**RE: Response Letter
Notice of Intent – Parallel Products (SE49-0771)
100 Duchaine Blvd. – New Bedford, Massachusetts**

We have enclosed a response letter, revised HydroCAD calculations, revised Site Plan sheets and accompanying documentation in response to the comment letter prepared by Nitsch Engineering dated September 1, 2017 in regards to their review of the Site Plans and attached documents.

Nitsch Engineering Comments

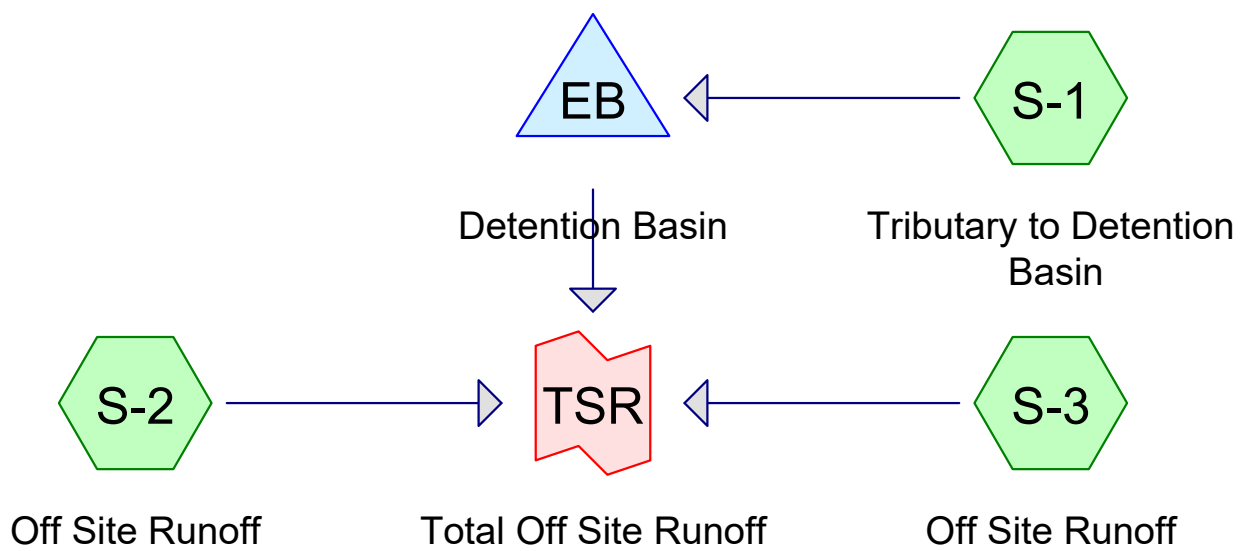
Comment #9:

The plans seem to imply that there is a stone diaphragm proposed along the paved pad. The pad also contains a water quality treatment device. It is unclear whether all the stormwater runoff over the pad is intended to flow towards the water quality structure. If so, there should be curb shown on the plans that directs water to the structure.

There is a proposed Cape Cod Berm at the edge of the pad to direct stormwater runoff back towards the structure, and it has been shown on the Grading & Utilities plan.

WATER QUALITY INLET STRUCTURE

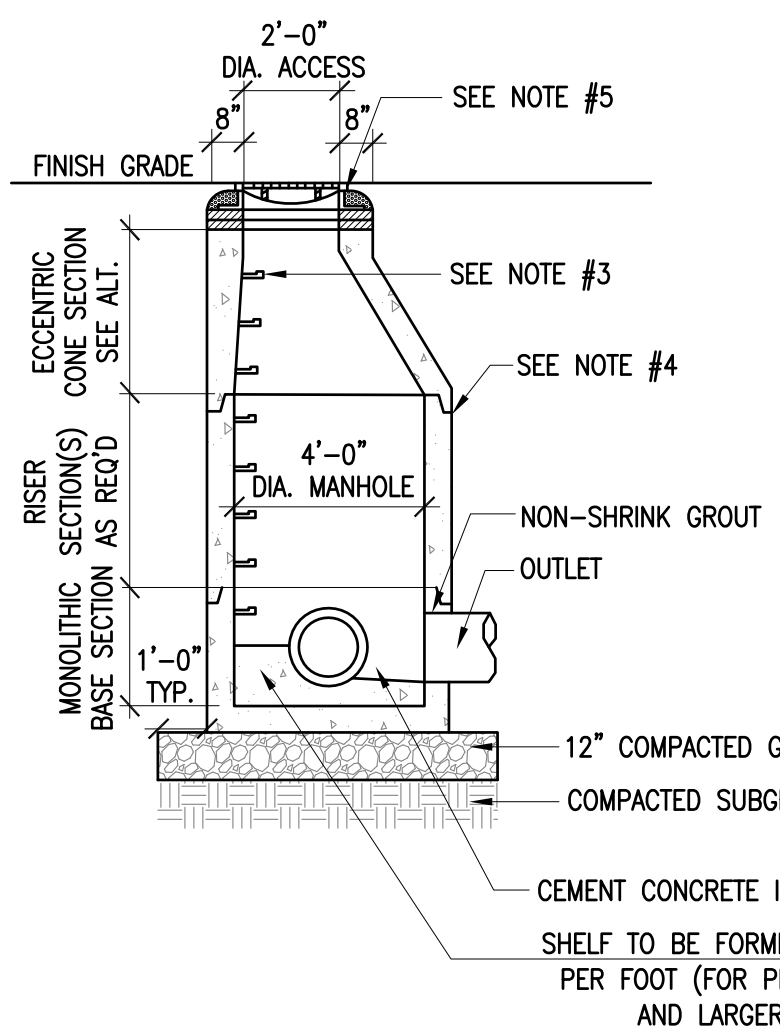
Comment #10:

A water quality treatment device detail should be added to the plans.

This has been added to the detail sheet.

T.H. #2
EL. 81.4±

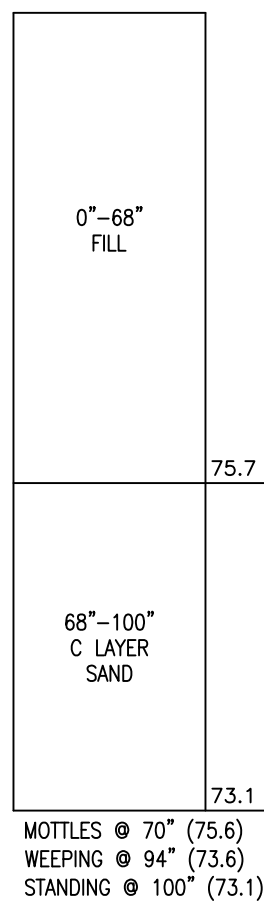
Comment #3:

The applicant should perform a test hole in the vicinity of the proposed underground infiltration facility to determine seasonal high groundwater elevation and insure that there is two feet of separation between the bottom of the system and seasonal high groundwater. The detail shows seasonal high groundwater elevation as 96.7, which is incorrect.

Test hole #2 is located in the close vicinity of the proposed infiltration system, and the soil logs have been added to the detail sheet highlighting encountered soil conditions.
